**TRAFFIC IMPACT MEMO
ADDITIONAL CONCEPT PLAN**

**The Dover Transit Center
Water and Queen Streets**

Prepared by
Orth-Rodgers & Associates, Inc.

RE: DOVER TRANSIT CENTER

scale 1"=70'-0"
 Dover Transit Center
 Dover DE

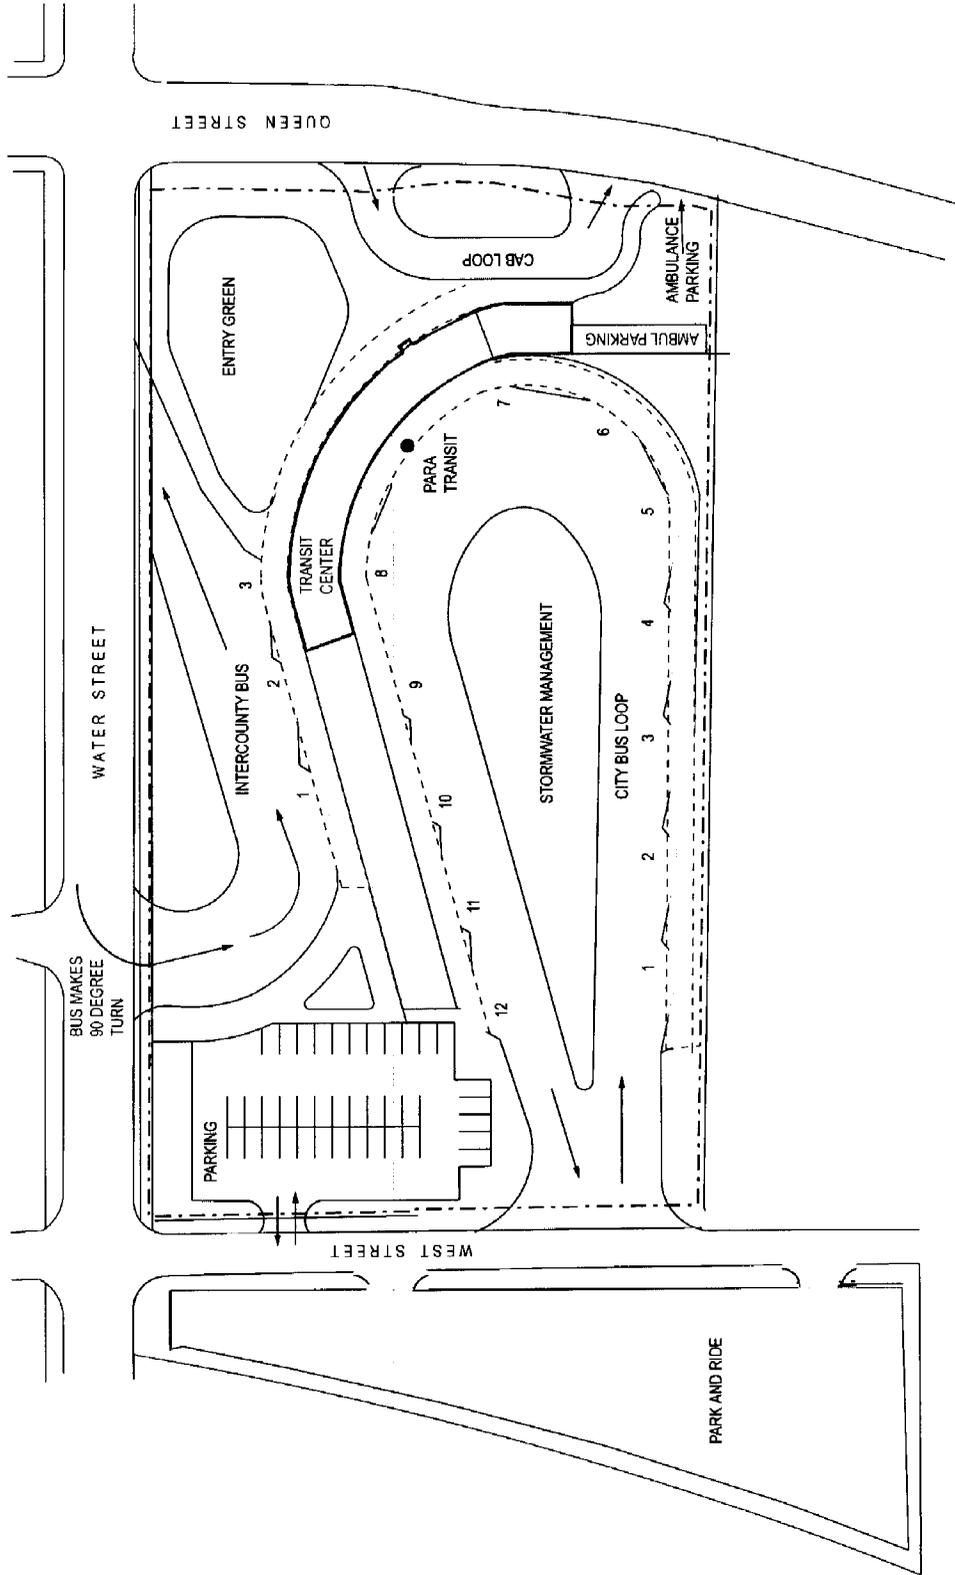
1. General Comment
 - Compared to other alternatives, this concept does the best job of separating different modes of transportation (bus/ambulance/cab/parking).
2. Bus Access
 - A beneficial component of this concept is that no bus access is planned on Queen Street. Since Queen Street has the highest amount of traffic of all frontage roads, it would be the most difficult access point for busses, particularly for busses turning left. Also of note is the redesign of the city bus loop road so that both the entering and exiting movements are made as a single driveway location. Utilizing West Street and Water Street for bus traffic appears to be the best option.

- The Intercounty/Greyhound access driveways on Water Street will likely operate with left and right-turns in and right-turns out only. This seems to be a desirable design, because the busses will then be able to head east on Water Street without having to turn at the intersection of Queen and Water.

- Some consideration should be given towards minimizing the total number of “curb cuts” along the site’s frontage. Along West Street, there are four driveways (two on each side) which are offset. We recommend redesigning the two Park and Ride parking lot access driveways to align with the parking lot driveway and Bus Loop Driveway on the east side of West Street. This change will help separate and distinguish the bus access and parking lot access, it will reduce the number of conflict points for motorists as well as pedestrians and it will reduce the potential of having motorists enter or exit at the wrong locations.

3. Ambulance Parking/Access & Cab Loop
- Access to the Ambulance parking is provided via a third driveway on Queen Street, just south of a Cab Loop entrance and exit driveway. We recommend eliminating this third “curb-cut” and provide an internal access to the Ambulance parking lot from the Cab Loop area.

- The Cab Loop along Queen Street shows two access points, one separate entering and one separate exiting driveway just south of Water Street. It should be noted that the northern most entrance access point would be located close to the signalized intersection of Queen and Water Streets. Turning left into this access point may be difficult due to queues associated with the traffic signal. It is our recommendation that the north entrance driveway be right-turn in only with the south exit driveway allowing left and right-turns. It should be noted that left-turning traffic may experience increased delays at this location. However, considering that this is a loop road for cabs and ambulances (no busses), we do not expect any significant queuing to be caused by this access.

4. Parking Lot Access and Design
- Since the proposed parking lot on the east side of West Street is shown with a single access point and less on-site parking compared to other concept plans, a one-way flow with angled parking may produce more parking spaces.

- Consideration should be given towards defining how these lots will operate and who will be able to park in each of those lots. For example, the lot on the east side of West Street could be gated and reserved for DART employees, while the lot on the west side of West Street could be open to the public.

- For the Park and Ride lot on the west side of West Street, a marked crosswalk should be provided for pedestrians crossing from the southwest corner of Water/West Streets to the southeast corner of Water/West Streets. Consideration should also be given to how pedestrians will cross West Street to get to the Transit Center if they are parked on the southern end of the lot, as it is unlikely a pedestrian will walk all the way to the north to utilize the above mentioned crosswalk. Possible recommendations could be for a mid-block pedestrian crosswalk along West Street.
